Overheating Risk Assessment

138-144 Friar Street

For National Pub Portfolio Limited

July 2026

Figure 3. Top: Initial design of east elevation with limited openable areas, bottom: updated design of east elevation with Juliet balconies and larger openable windows.

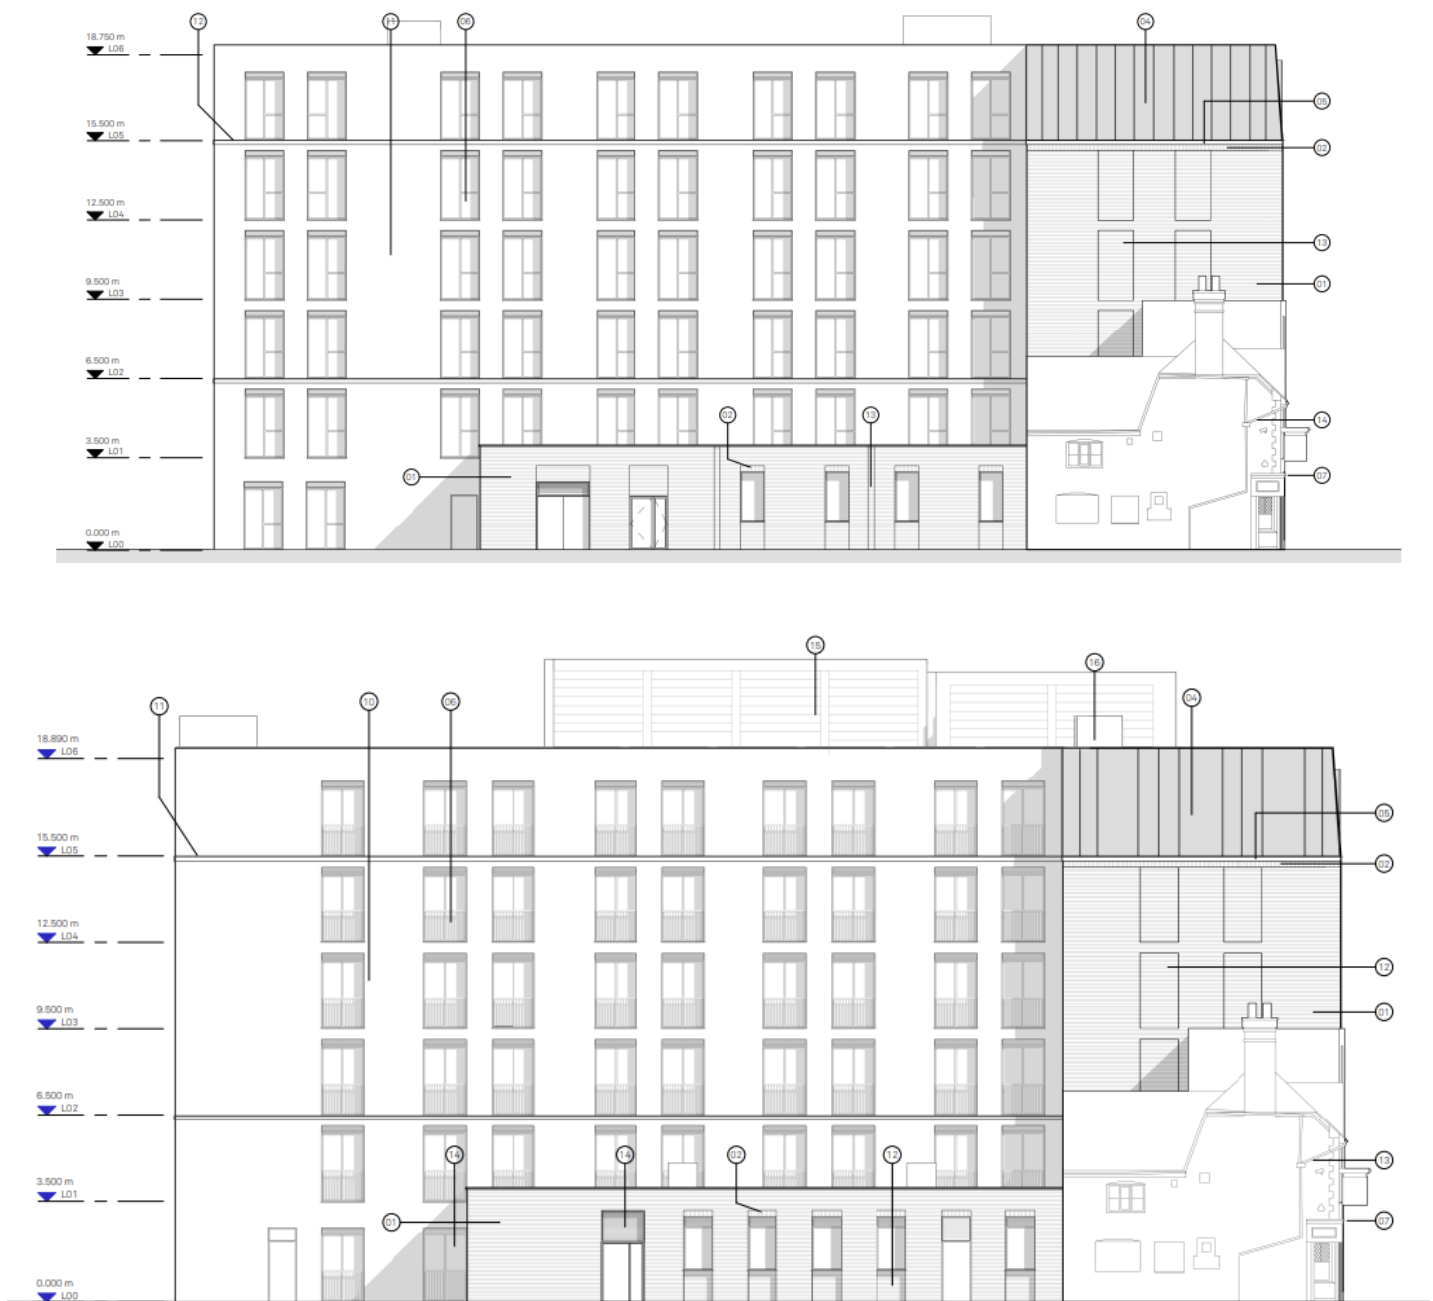
Examples of the evolution of the elevations at RIBA Stage 2 are illustrated in Figure 3. This principle applies to all facades across the scheme.

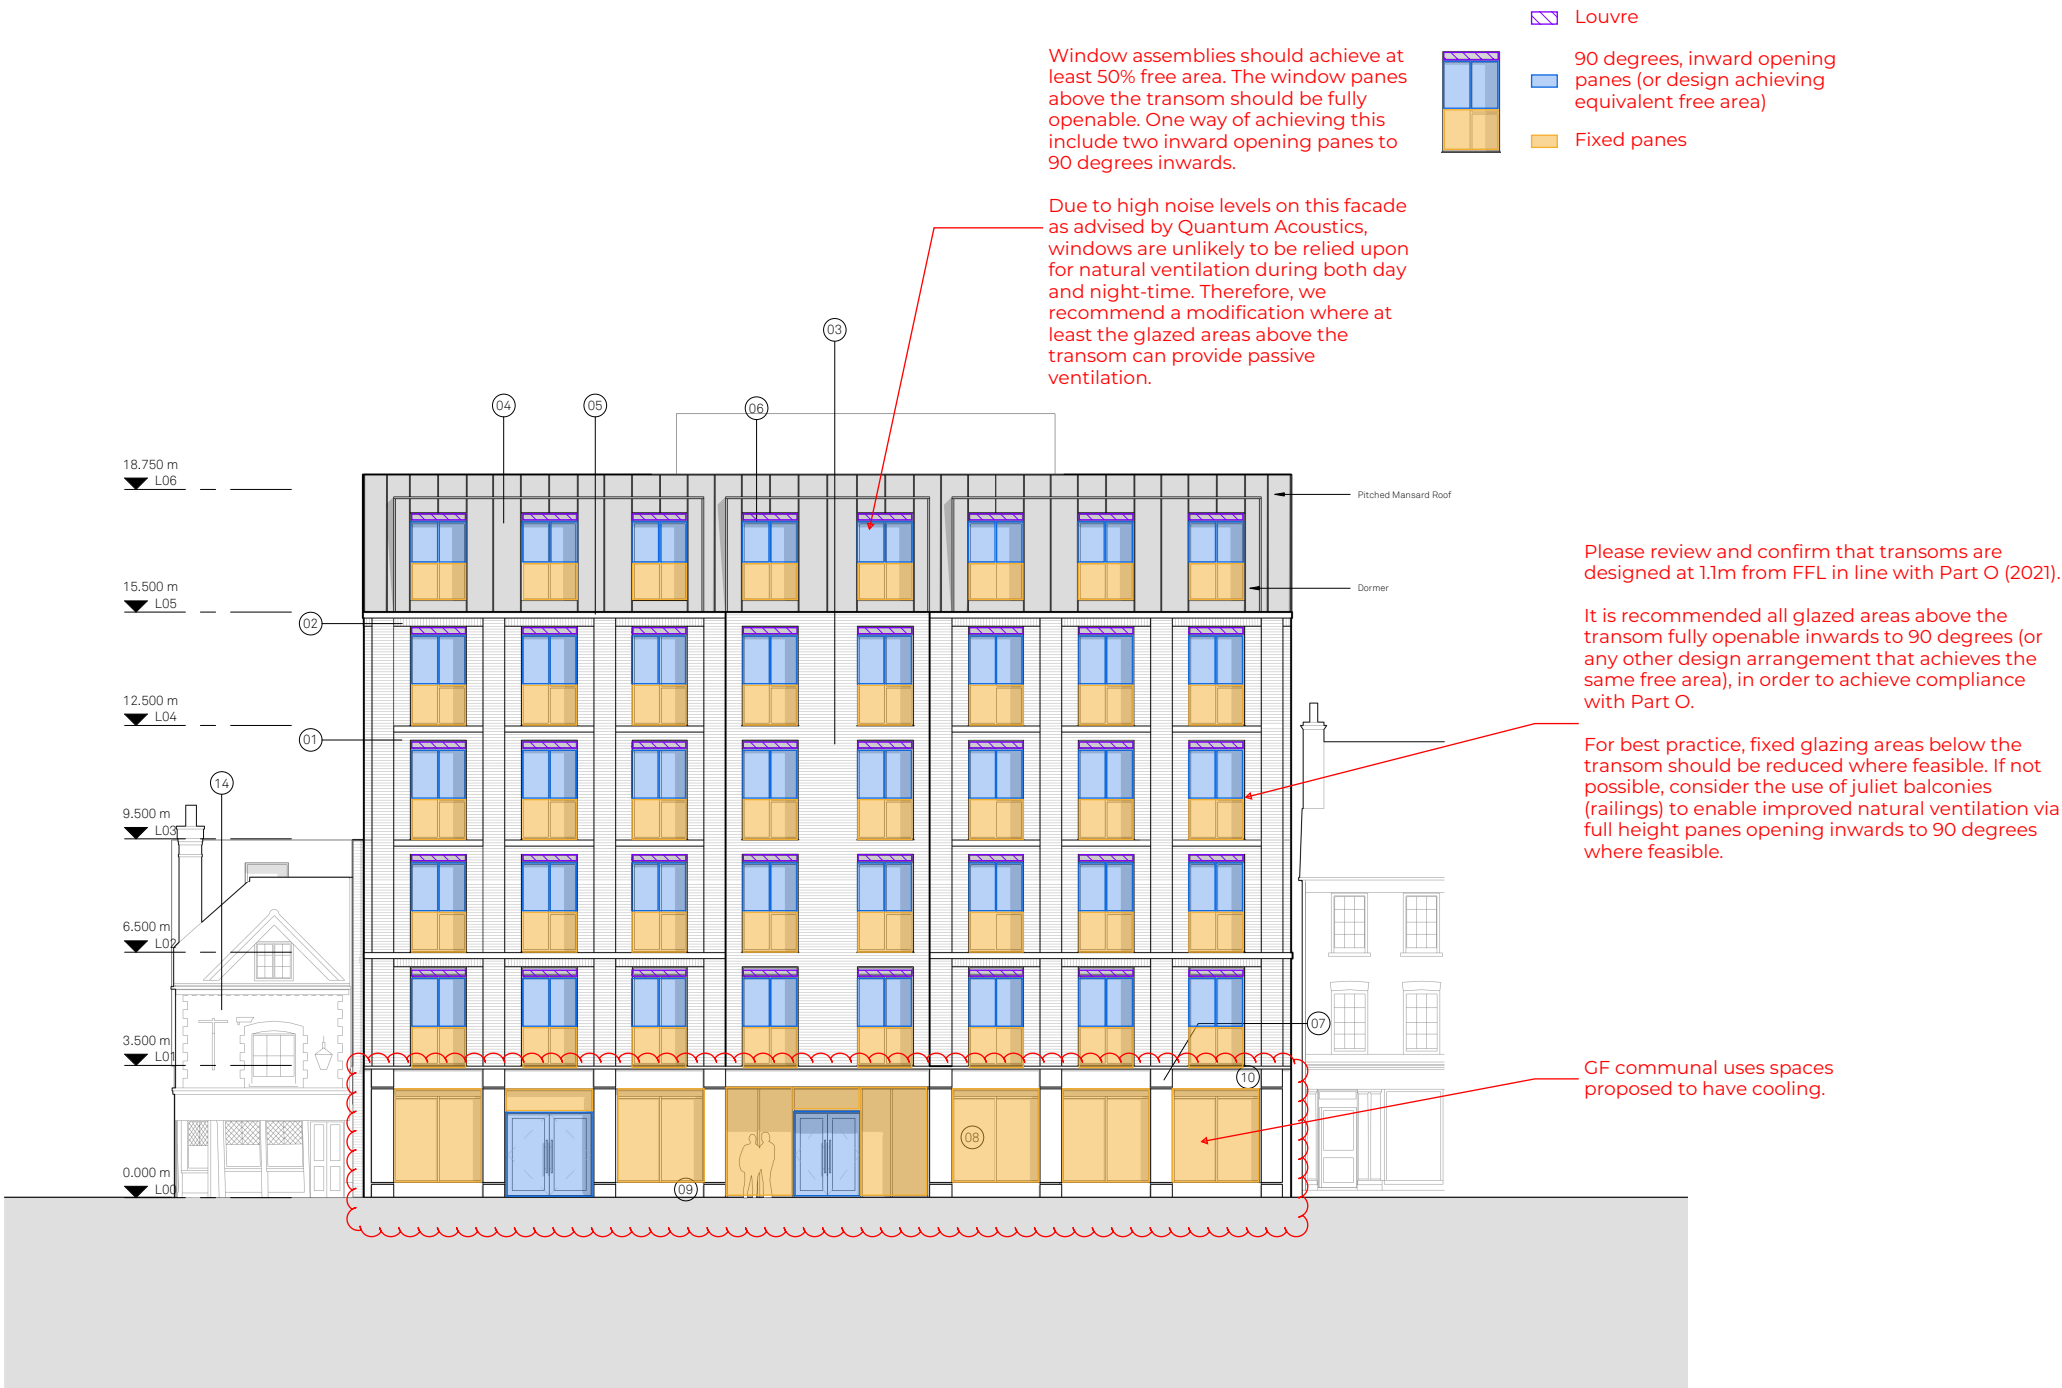
1) All windows to have a g-value of 0.4.

2) Please review transom or bottom of window heights for all window assemblies on upper floors where there is risk of falling. Part O (2021) guidance requires transoms to be at 1.1m above FFL to enable openable windowpanes above the transom to be fully openable.

5) Current assessment based on ADO (2021) and CIBSE TM59 (2017). Final strategy to be confirmed based on ADO calculations to be carried out at detailed design and construction stages post-planning with the applicable guidance and regulations at the time of detailed design and construction stages.
